*STP-209-1(2) Roadway and BHF-209-1(3) Bridge  
Widening of SR 74 From SR 85 to*

*P.I. Nos. 322355 and 322357*

**Value Engineering Study Report**

Preliminary Design Stage

DRAWING NO. 24-05

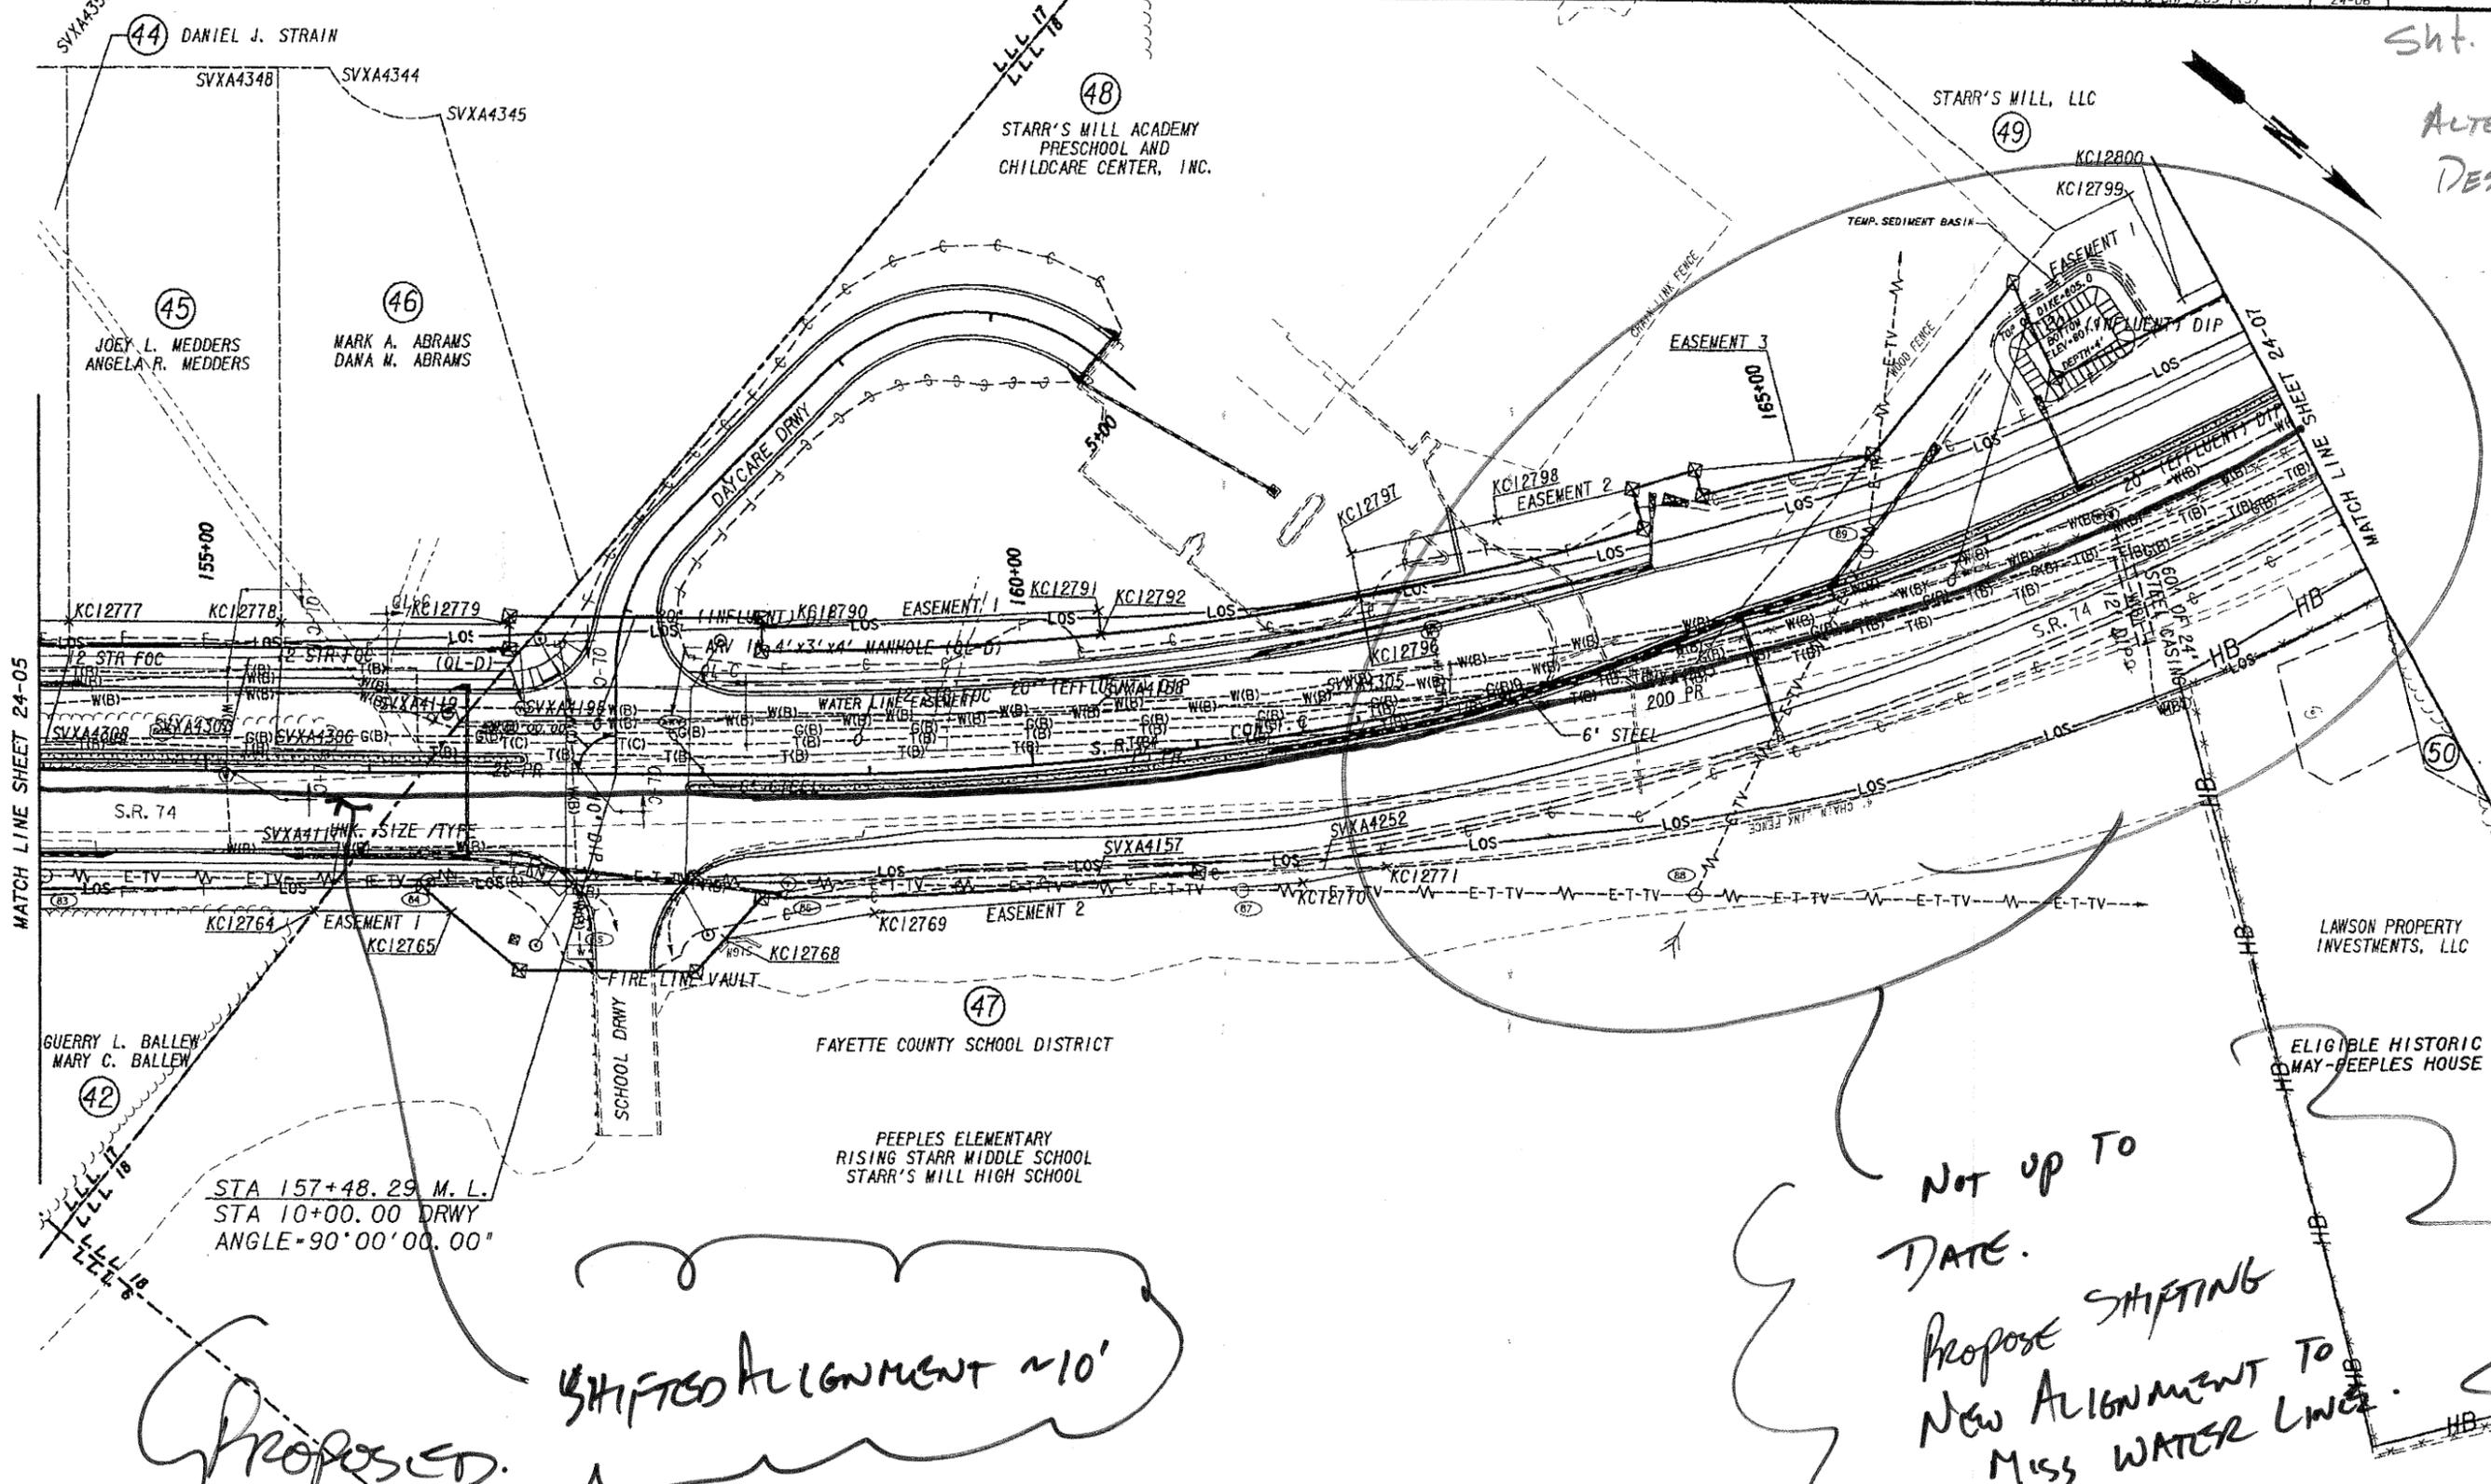
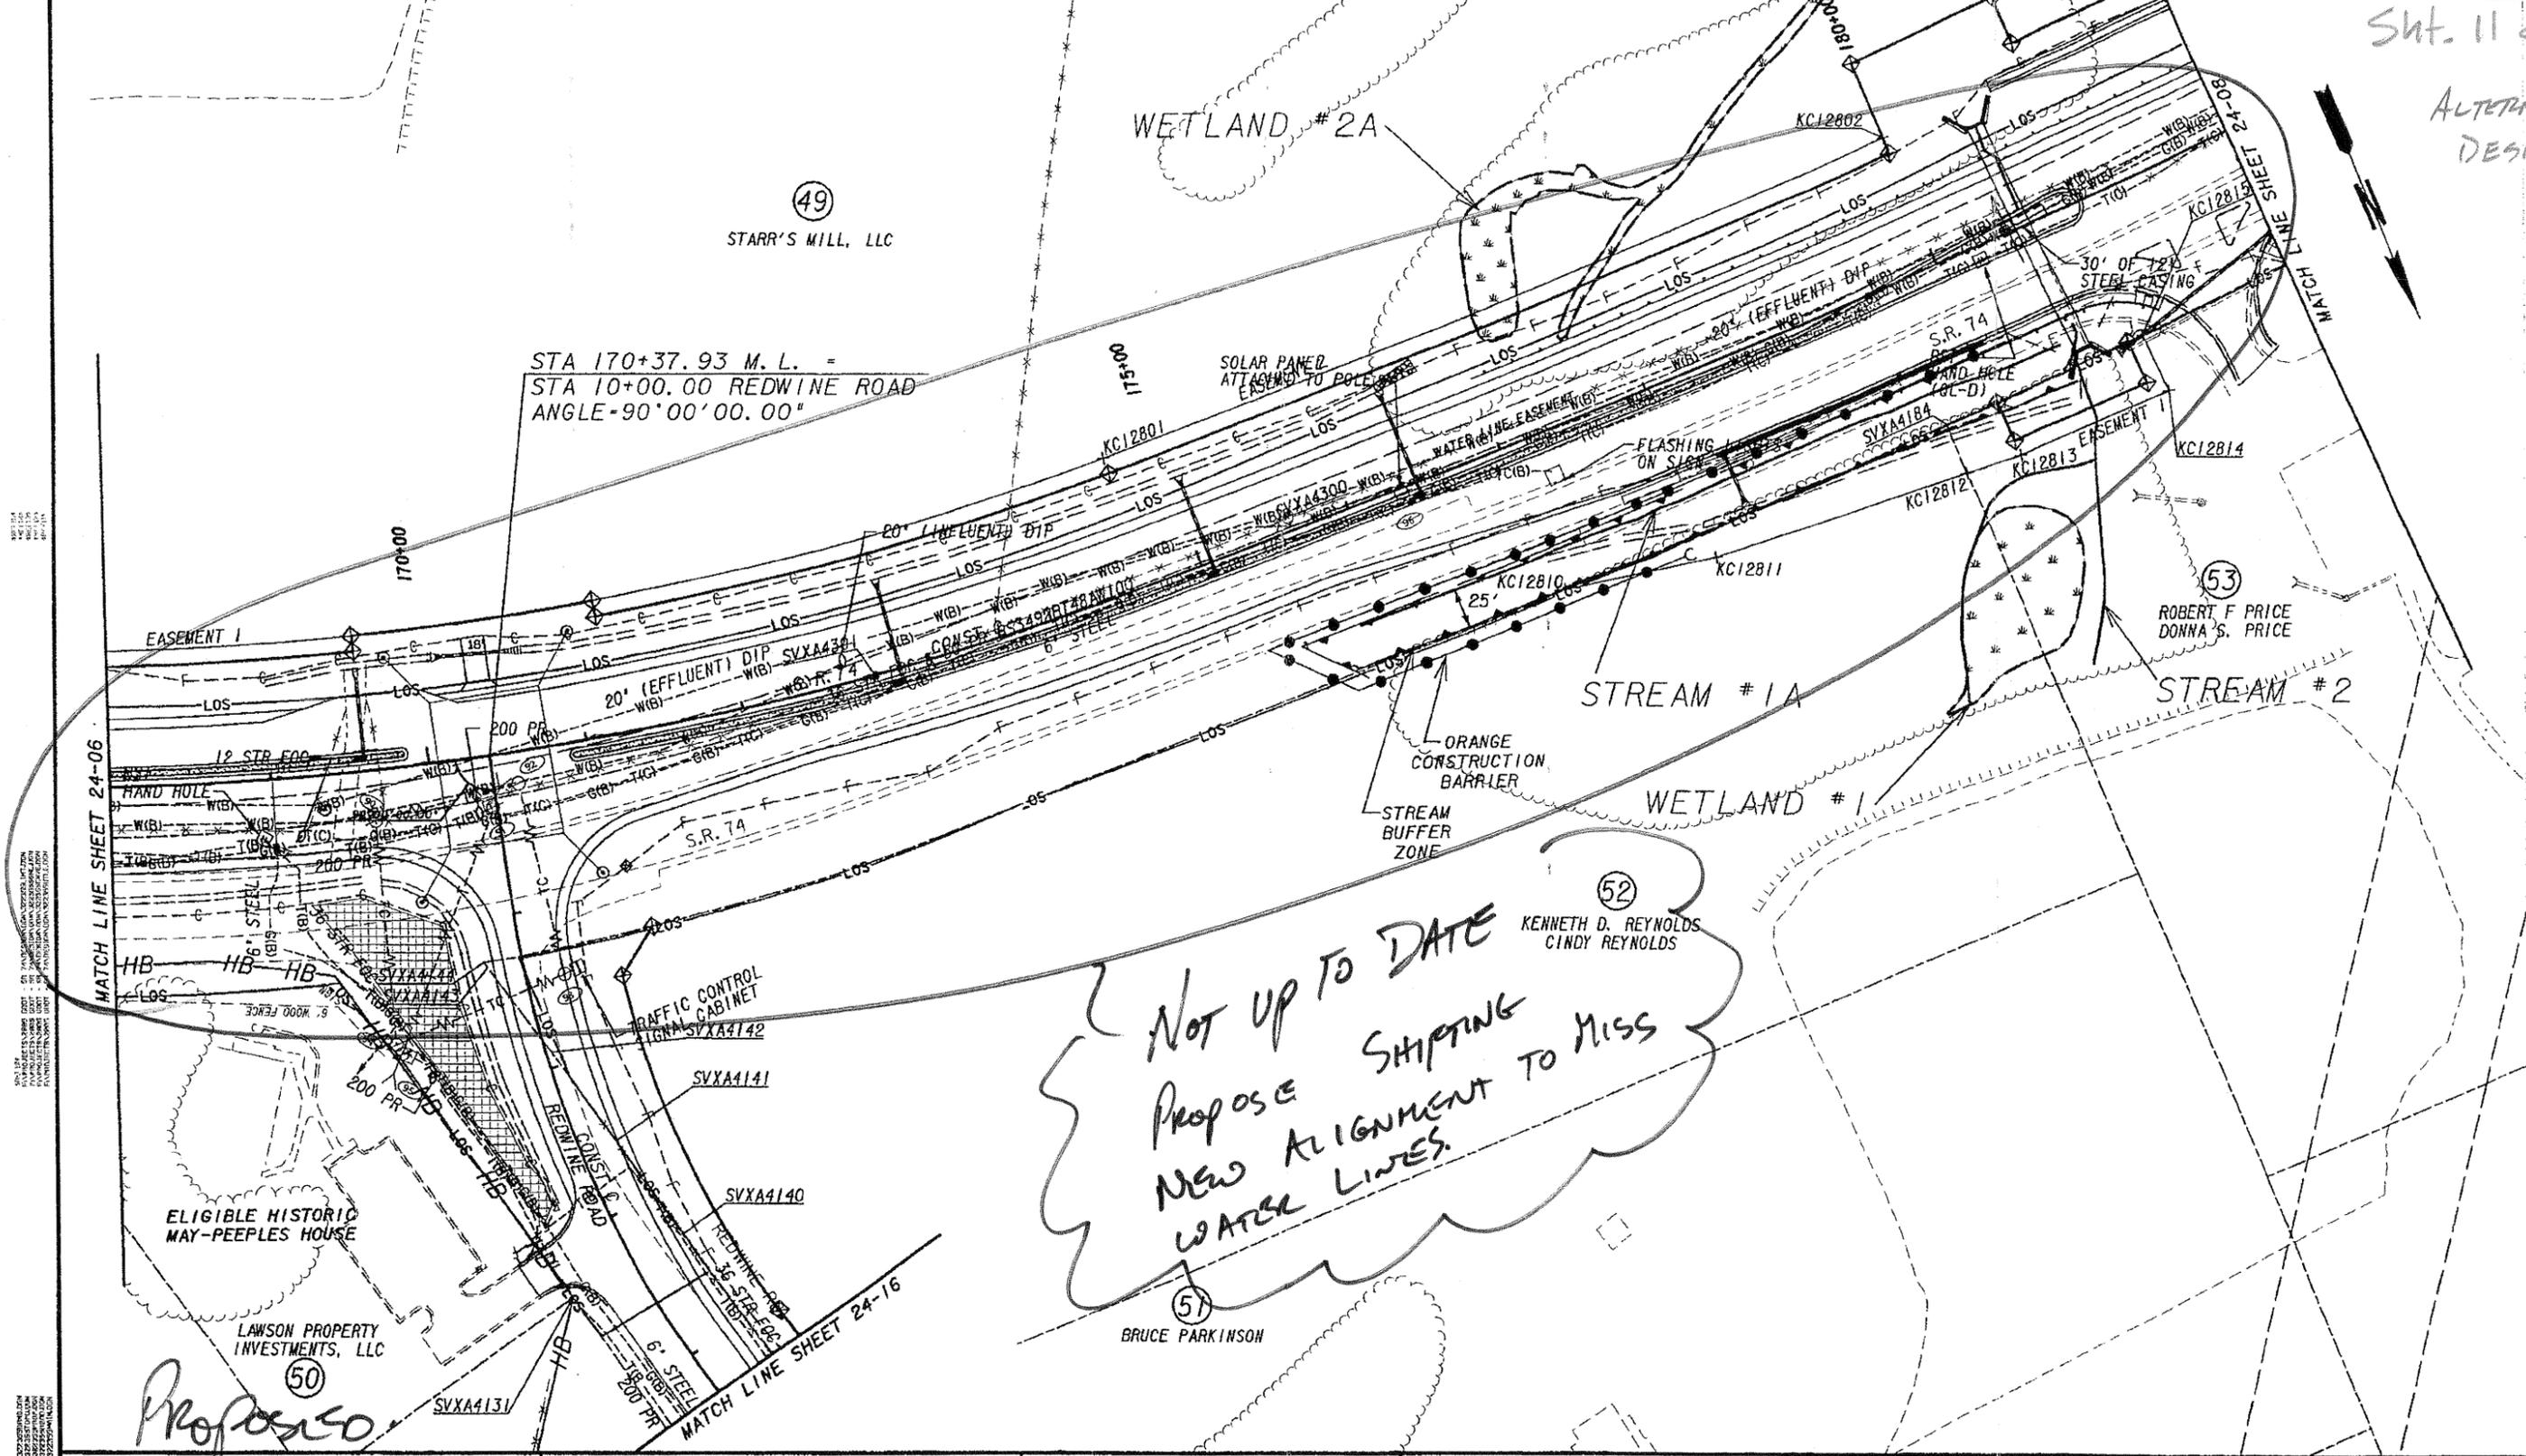
Not up to date  
Propose shifting  
new alignment to miss  
water lines.
